STATE OF NORTH CAROLINA
DEPARTMENT OF TRANSPORTATION

January 30, 2009

Subject: **Request for Section 404 Nationwide 23 Permit Modification and Nationwide 13 Permit Issuance** for the replacement of Bridge No. 56 on SR 1763 over the North Muddy Creek, McDowell County. Federal Aid Project No. BRZ-1763(1), WBS No. 33108.1.1, TIP Project No. B-3492.

Permit Drawing
Sheet 11 of 12
Revised 1/16/09

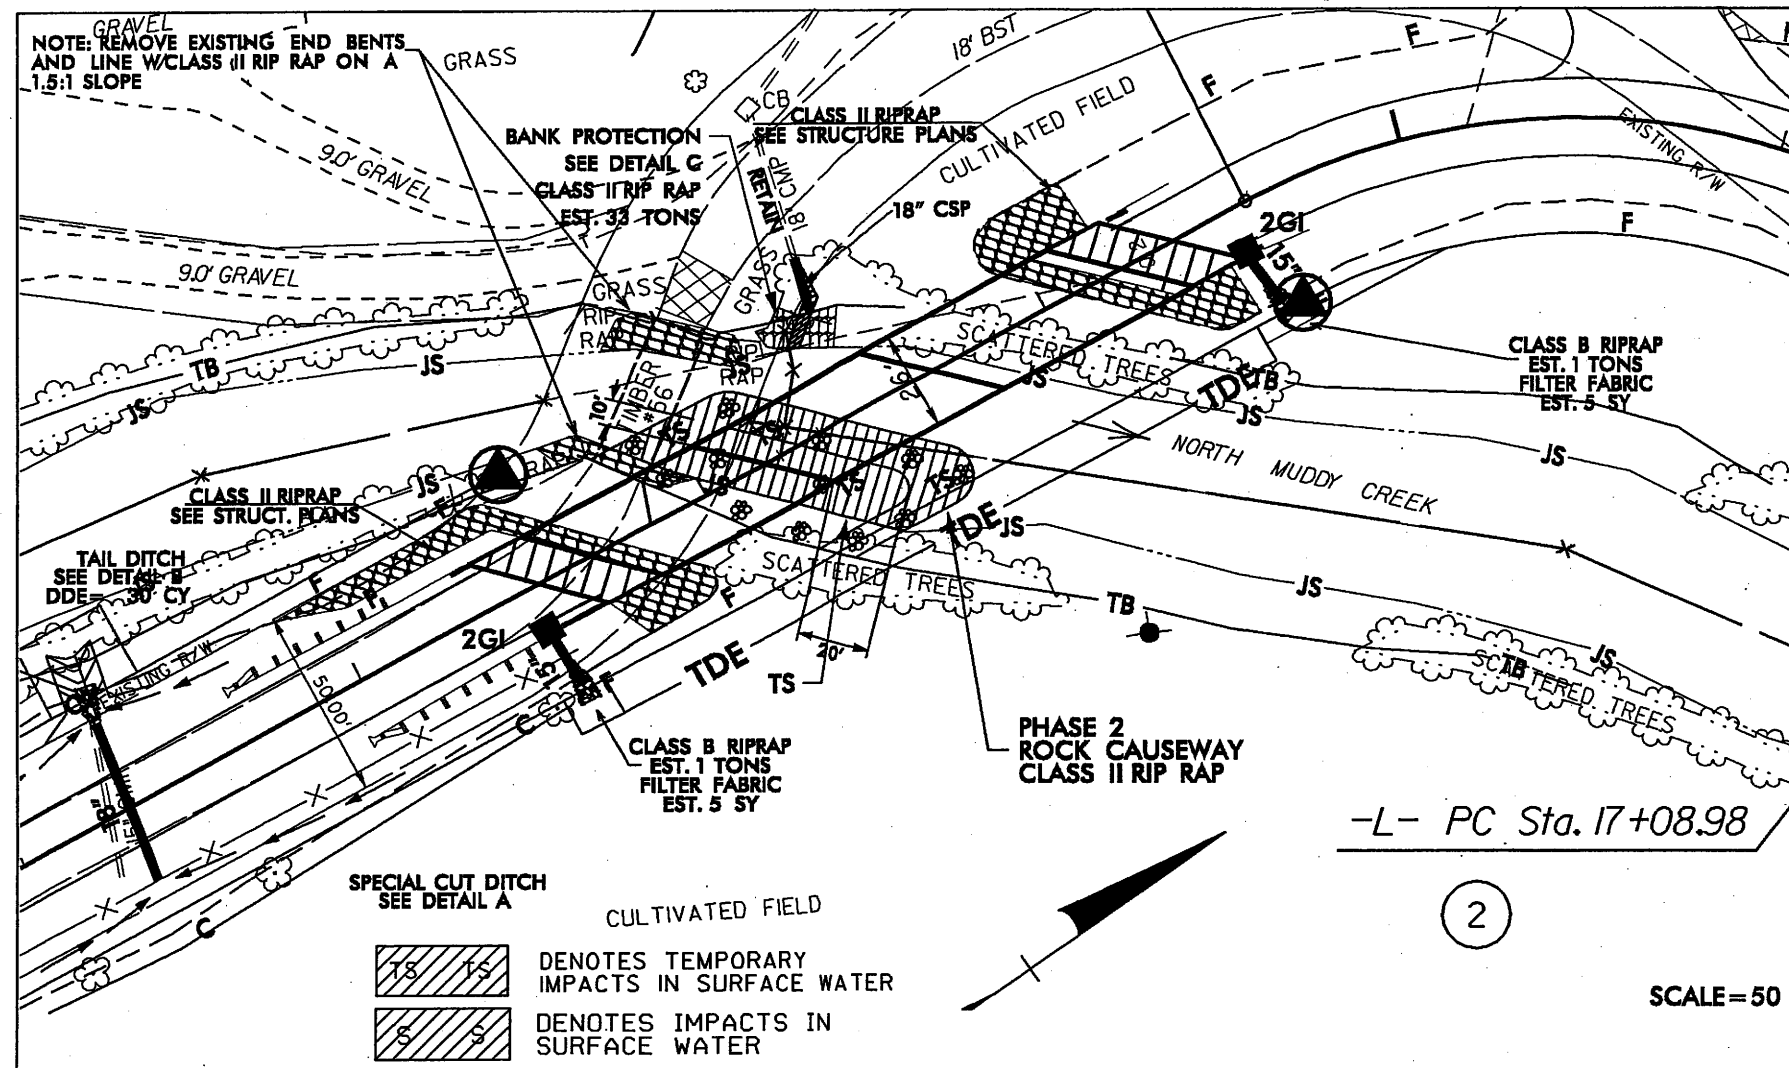
The purpose of this letter is to request a modification to the United States Army Corps of Engineers (USACE) Nationwide Permit Number 23 and issuance of a Nationwide Permit Number 13 for the above referenced project. The requested modification addresses the need to extend the current 18-inch pipe that carries an unnamed tributary (UT) under SR 1763 to North Muddy Creek. Please see the attached, revised permit drawings (Sheets 5, 6, 7 and 11) that replace the original drawings.

The 18-inch CMP will be extended 16 feet from the outlet of the existing pipe. Class II rip rap will be used as bank stabilization along the UT from the outfall of the pipe extension to the bank of North Muddy Creek equaling a distance of 9 feet. This work will result in a total of 25 feet of permanent impact (Sheet 3 of 12). The pipe needs to be extended because the existing pipe does not extend beyond the edge of road pavement and is 8-10 feet below the roadway grade. By extending this pipe, it allows this area to be filled and provide a safe shoulder for what will eventually become a driveway.
